MEMORANDUM –

TO: District of Columbia Zoning Commission

SUBJECT: Final Report for Z.C. 07-21 B
Major Modification to an Approved Consolidated Planned Unit Development
2201 M Street, N.W. (formerly known as 2213 M Street, NW)

5. Looking East on M Street

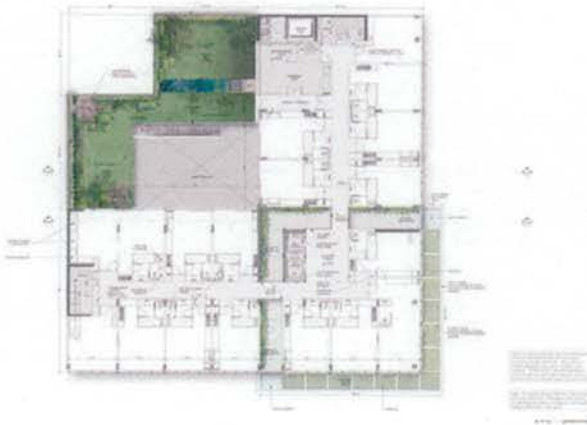
- a. *Design and Setback of Roof Structure:* The applicant has addressed the Commission's concern that design of the wall abutting the west adjacent M Street property exaggerated the impression of the building's height. A comparison of Exhibit A, Sheet A3 of the applicant's October 7, 2011 filing with the same sheet in the applicant's June 20, 2011 filing illustrates the new design changes. They show a clearer contrast between the building block and the roof structure while also distinguishing the service elements of the building from the inhabited areas. The revised design increases the roof structure back from the wall by an additional two inches.

8. Roof Level Plan

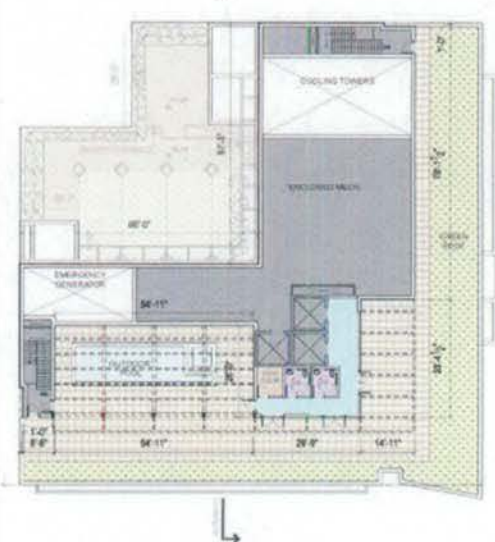
- §636.1: Rear Yard Requirement: No change from approved relief:
- §629: Roof Structure Requirements: The applicant received relief to construct three roof structures, rather than the one permitted by the zoning regulations. The modification proposes the construction of a roof structure with one enclosure. The previously approved relief would no longer be required.

The applicant had also received 12'6" of relief from the 1:1 setback required for roof structures from the outside walls. The applicant is now seeking an increase in that relief to 17' 4", proposing to provide one foot of setback from the side and rear lot lines, which neither face nor are visible from streets, and 8" of setback from the of the western side property line adjacent also not facing, but visible from, a street and adjacent to a lower existing building.

The proposed modification would contain all of the alternate features, except for a publicly accessible roof deck, which would be replaced by an outdoor rooftop pool reserved for hotel guests. The approved 3855 square foot restaurant would be resized to 3662 square feet.
